AMENDMENTS TO THE DRAWINGS

REMARKS

Newly added

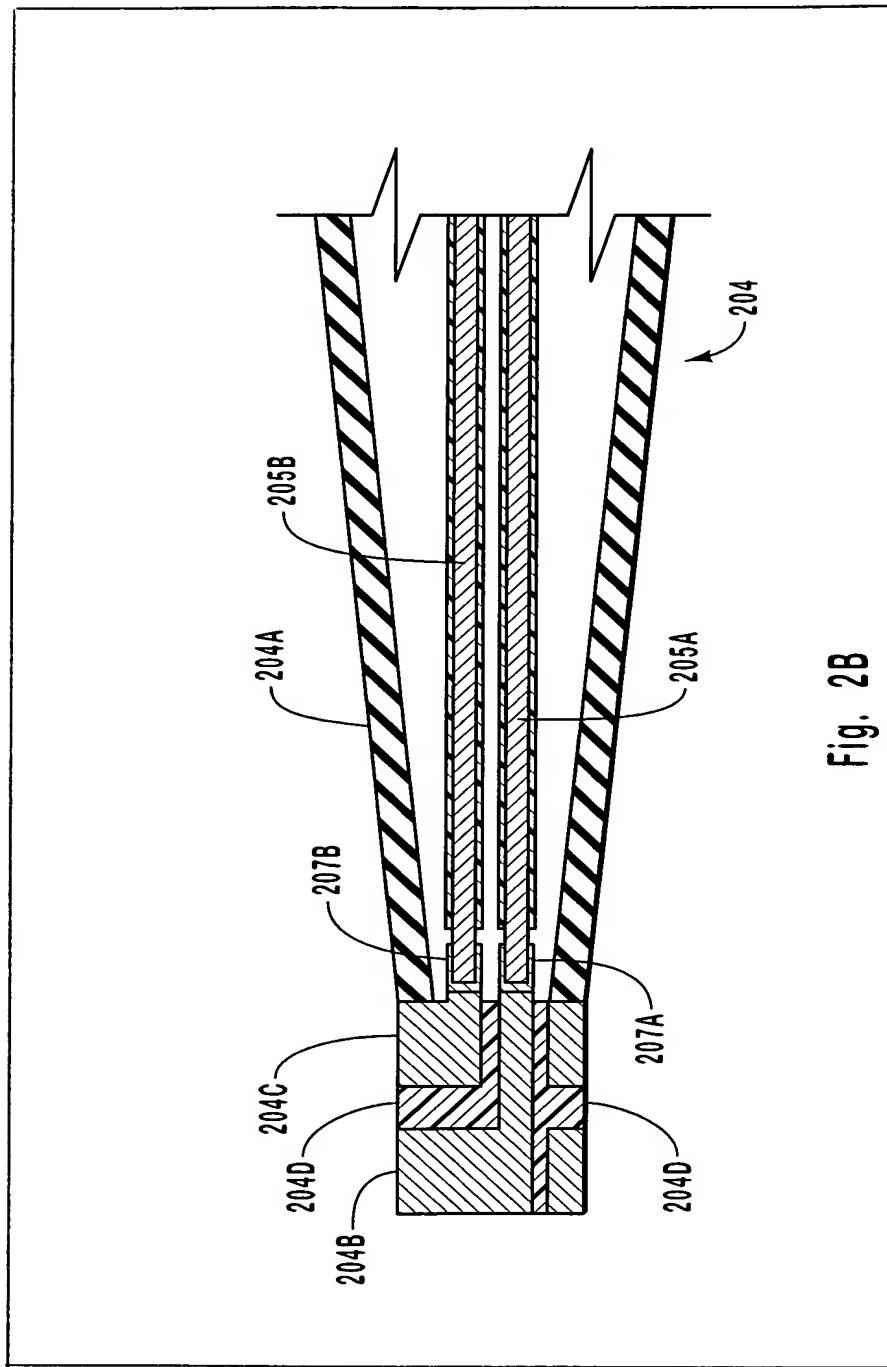
1. *plurality of conductors of a cable*

3. ***plurality of electrical contacts in electrical communication with conductors of the cable***

9. ***plurality of conductive elements within the terminal***

10. ***conductive elements in electrical communication with the conductors of the cable***

11. ***plurality of contacts in electrical communication with the conductive elements***

In light of the addition of Figure 2B herein, showing conductors 205A and 205B, Applicant submits that the objection as to this feature should be withdrawn.

Applicant submits that in light of the addition of Figure 2B herein, illustrating electrical contacts 204B and 204C in electrical communication with conductors 205A and 205B of a cable, the objection as to this feature should be withdrawn.

Applicant submits that in light of the addition of Figure 2B herein, illustrating a plurality of conductive elements 207A and 207B disposed within the terminal 204, the objection as to this feature should be withdrawn.

Applicant submits that in light of the addition of Figure 2B herein, illustrating conductive elements 207A and 207B in electrical communication with the conductors 205A and 205B of the cable, the objection as to this feature should be withdrawn.

Applicant submits that in light of the addition of Figure 2B herein, illustrating a plurality of contacts 204B and 204C in electrical communication with the conductive elements 207A and 207B, the objection as to this feature should be withdrawn.

Fig. 3A

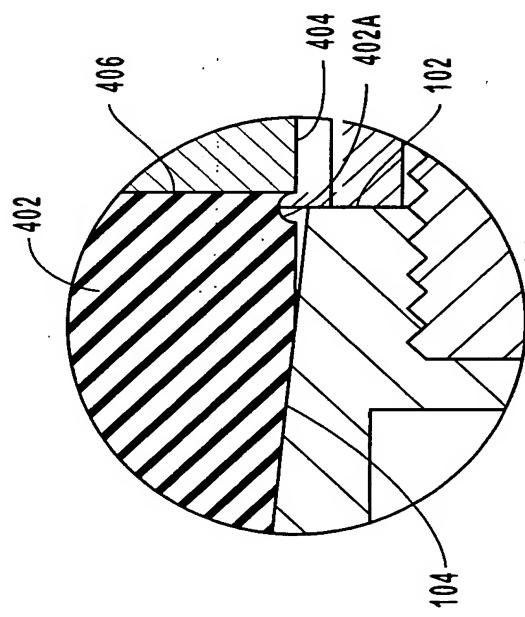
4. ***annular groove proximate the joint***

5. ***annular groove to be an ellipse or circle***

Applicant disagrees with the Examiner and notes that Figure 3A, for example, clearly shows an annular groove 402A located proximate the joint 406. Applicant accordingly submits that the objection as to this feature should be withdrawn.

Applicant disagrees with the Examiner and notes that Figure 3A, for example, indicates that in one embodiment, the cross-section of the annular groove 402A comprises a portion of a circle, moreover, claim 7 has been amended to remove the reference to an elliptical cross-section. Applicant accordingly submits that the objection as to this feature should be withdrawn.
